TRUCK UTILITY LTWT MC2 LANDROVER SERIES 3 - ALL TYPES  
COVER VEH FITTED NSN 2540-66-095-8560 AND  
NSN 2540-66-096-4525

MODIFICATION INSTRUCTION

1. This instruction specifies the reinforcement of the canopy vehicle fitted over the rear canopy bow to prevent tearing due to flapping and stretching.

FIG 1 - POSITION OF REAR BOW REINFORCING STRIP

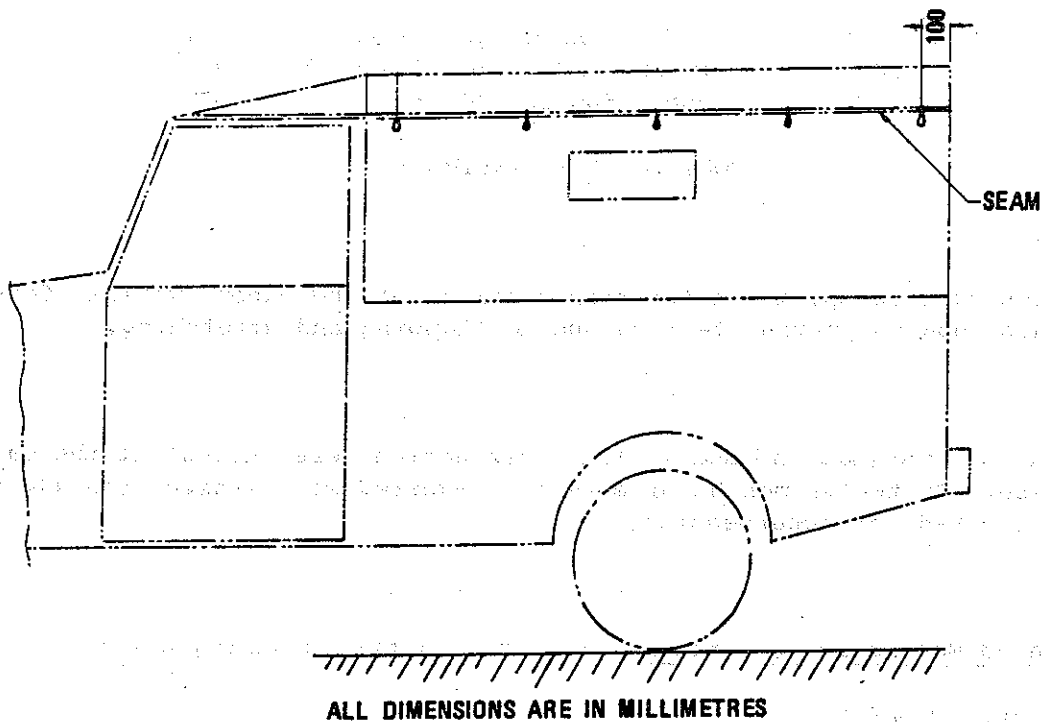
7. Modification procedure is as follows:
  - a. Remove canopy from vehicle.
  - b. Allowing for tucking, Cut a strip of CLOTH,COTTON,DUCK (Heavy Weight) at sufficient width to give 100mm width coverage over the bow and length to cover width of tarp from seam to seam (refer FIG 1)
  - c. Sew on strip as shown in FIG 2.
